These amendments revise the common Oconee Technical Specifications to incorporate changes to the Oconee Unit No. 3 pressurization heatup and cooldown limitations.

DUKE POWER COMPANY

SAFETY EVALUATION BY THE OFFICE OF NUCLEAR REACTOR REGULATION

OCONEE NUCLEAR STATION, UNITS NOS. 1, 2 AND 3

Figure 3.1.2-1C

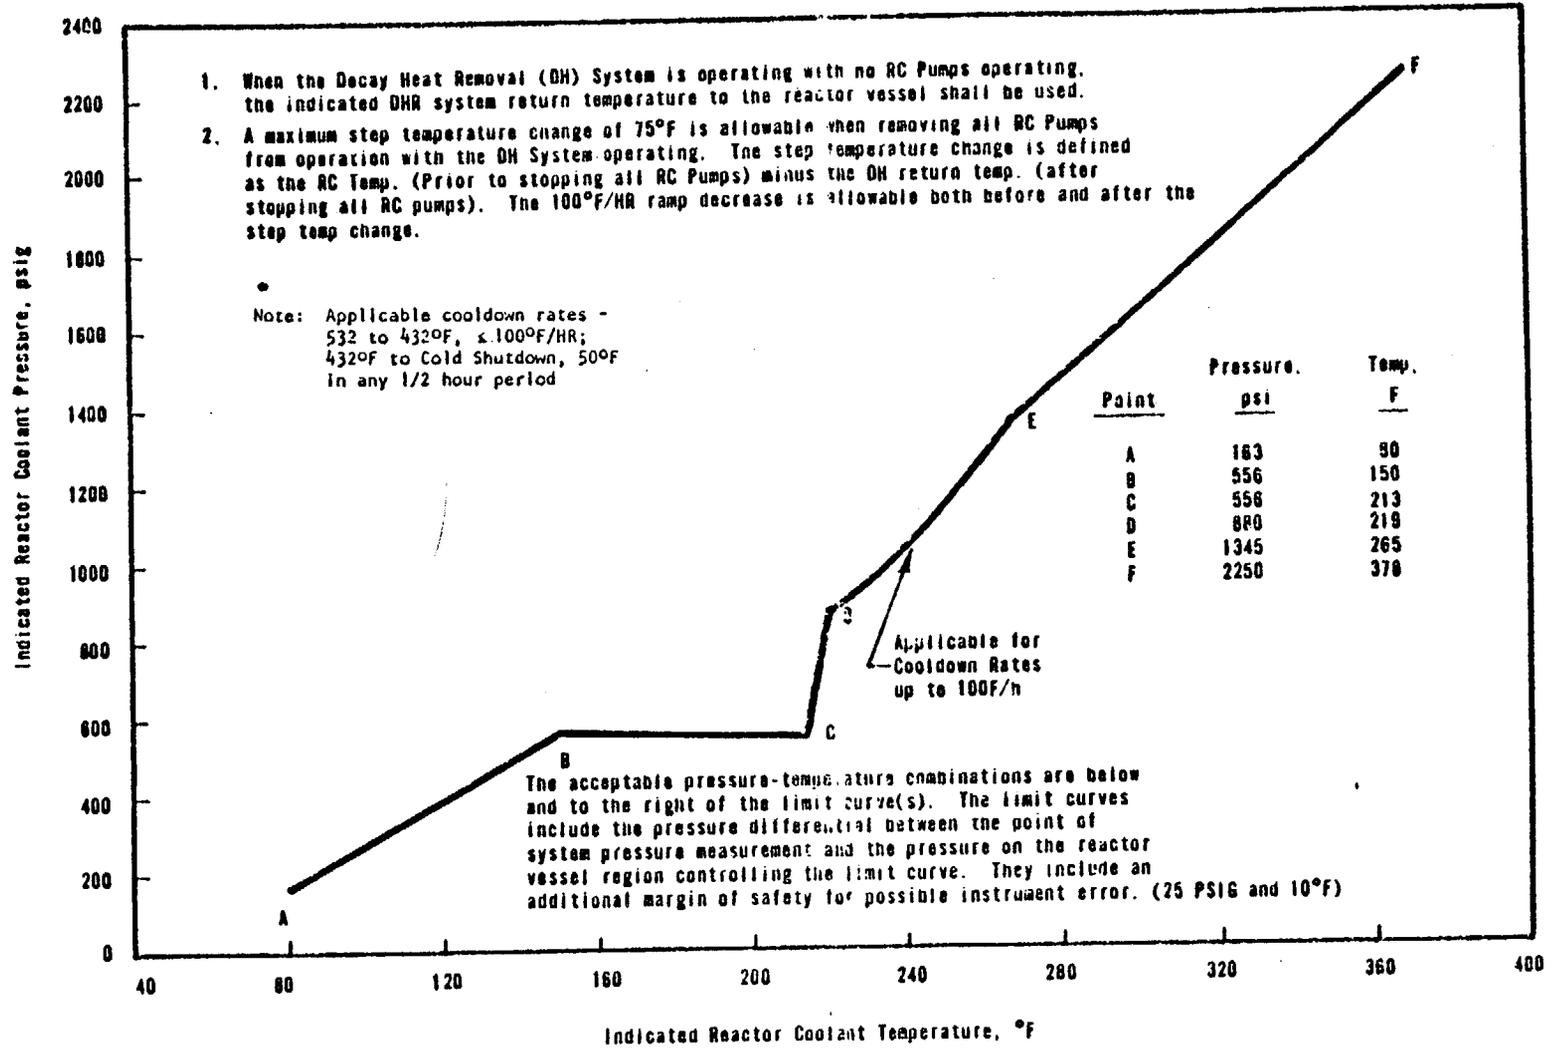
UNIT 3  
 REACTOR COOLANT SYSTEM  
 NORMAL OPERATION HEATUP LIMITATIONS  
 APPLICABLE FOR FIRST 4.0 EFY

The proposed revised Oconee Unit No. 3 pressure-temperature operating limit curves, Figures 3.1.2-1C, 3.1.2-2C and 3.1.2-3C are based on data from Babcock & Wilcox Report, "Analysis of Capsule OCIII-A From Duke Power Company Oconee Nuclear Station, Unit No. 3, Reactor Vessel Materials Surveillance Program," BAW-1438, dated July 1977. The proposed curves are projected for 8 EFPY.

We have reviewed BAW-1438 and the proposed pressure-temperature operating limit curves. Capsule A from Unit No. 3 contained specimens of weld metal WF 209-1. This weld is not identical to the welds in Oconee Unit No. 3. However, this weld has a similar chemical composition and was made using weld procedure similar to those for high copper Oconee vessel welds. Therefore, we conclude that the properties of the limiting weld metals in the Oconee reactor vessels will be affected by irradiation in a manner similar

Based on our review of the Oconee Unit No. 3 pressure-temperature limits and the similarity of the Oconee Unit No. 3, Unit No. 2, and Unit No. 1 designs, materials and operating conditions, we conclude that the operating limits proposed for Unit No. 3 are in conformance with Appendix G, 10 CFR Part 50, and are therefore acceptable.

Figure 3.1.2-2C

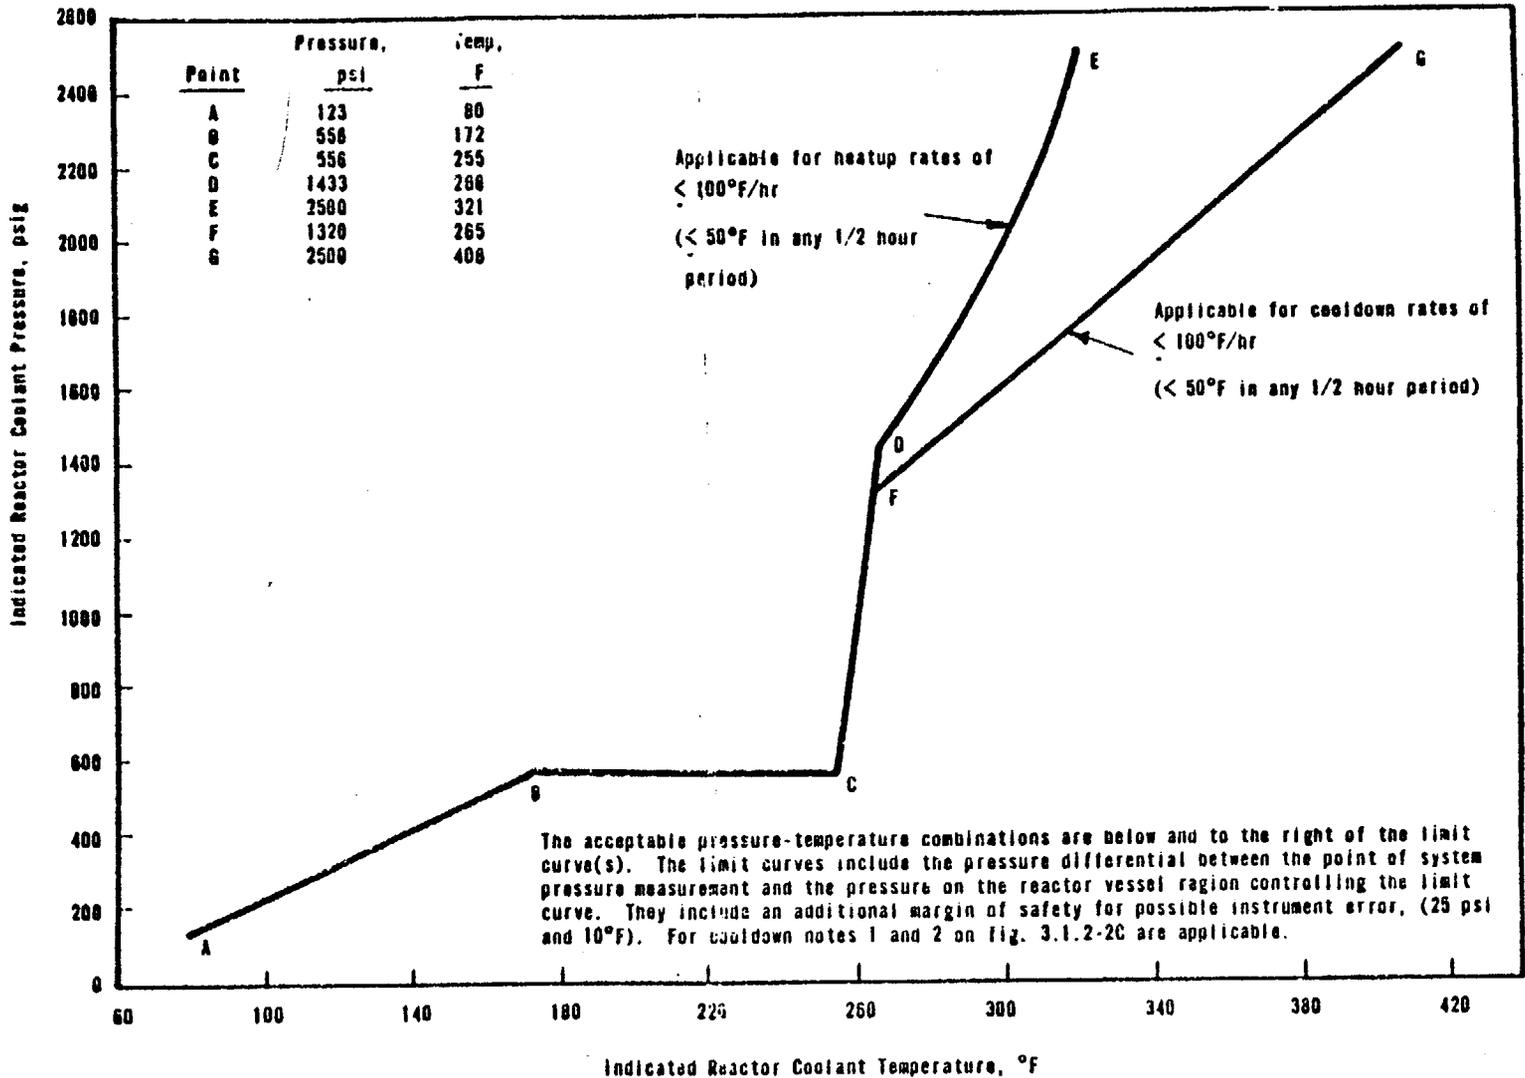
UNIT 3  
 REACTOR COOLANT SYSTEM  
 NORMAL OPERATION COOLDOWN LIMITATIONS  
 APPLICABLE FOR FIRST 4.0 EFY
